Memorandum

Date: April 22, 2005
Revised August 5, 2005¹

Subject: Overhead Sign Structure/Signal and Lighting Standards Policy

OVERHEAD SIGN SAFETY CABLE RETROFIT 1

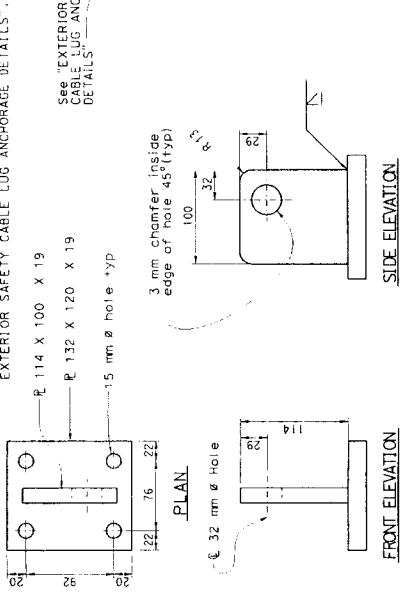
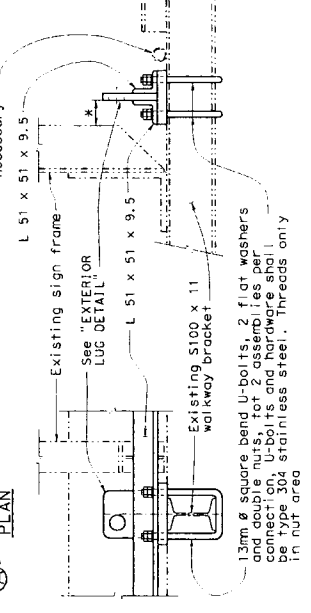
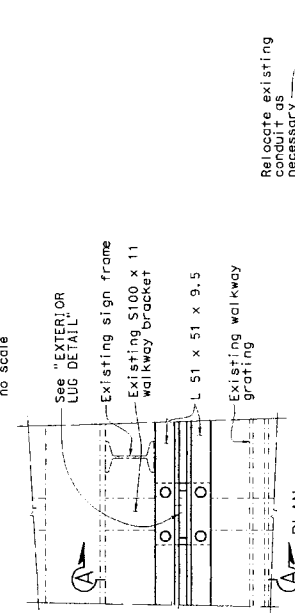
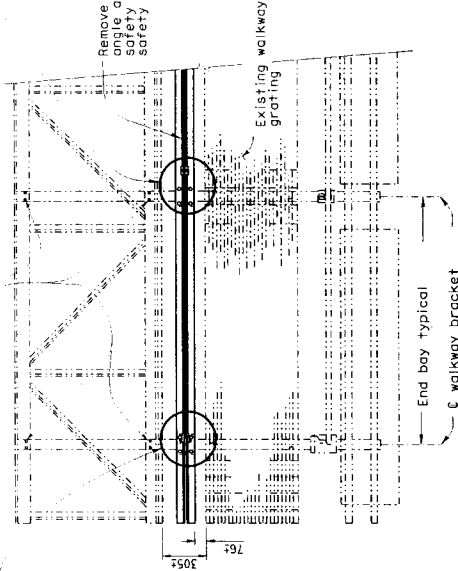
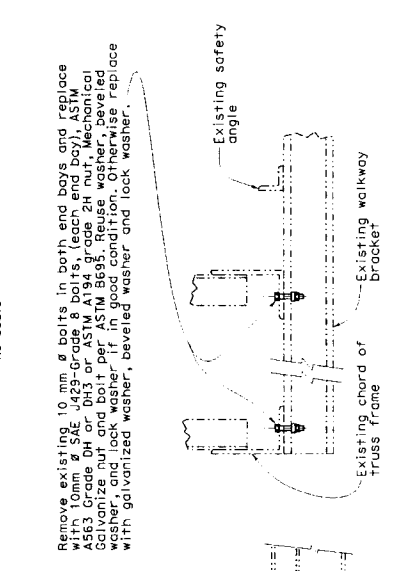
¹ Attachment C was revised to improve the structural performance of the "Overhead Sign Safety Cable" under full Cal/OSHA loading and to improve vertical clearance under the overhead sign structure. If original Attachment C has already been fabricated or installed, the installation does not need to be replaced with the new details. The new details shall be used on all future retrofits.

Attachment C- Replaced by
Attachment C "Overhead Sign Safety Cable
Retrofit 1 and 2" dated 6/27/05

1. Safety cable not shown in all views for clarity.
2. Unless otherwise shown all steel shall be galvanized after fabrication.
3. Stainless steel cable shall be 6 x 19 IWRC construction using type 304 stainless steel. Cable shall be 70 KN, minimum safe working load 11kN. Cable shall be free of kinks, knots, or deformation and shall be continuous with no splices. Safety cable shall not be prestretched.
4. Shackle shall be galvanized steel with working load limit of 57 KN.
5. Place an equal amount of washers on each side to align cable with end lug without restricting shackle ball rotation or contacting cable.
6. Prior to tightening cable clips at exterior anchorage, slack in cable shall be removed by the full effort of a typical construction worker.
